#tnl2016-0013e # 1 / 1

Change the Load Sensor Installed in the DGP8761

DGP8761 Dry polish specification

DGP8761 Poligrind specification

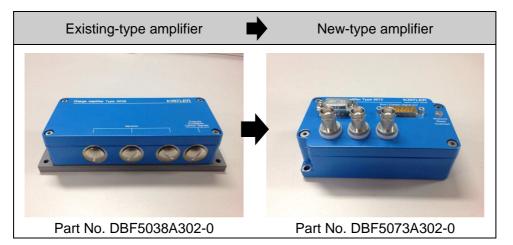
We change the load sensor installed in the DGP8761 and its relevant parts. From February 2016, any load sensors installed in the machines to be shipped are replaced by new ones in order.

- There are no changes in the features and performance.
- The appearance of the amplifier and the connection method are different.

• For the load sensor, amplifier, mounting bracket, and cable, it is impossible to use existingtype ones and new-type ones in combination. For the parts relevant to the load sensor, use them in the following combination.
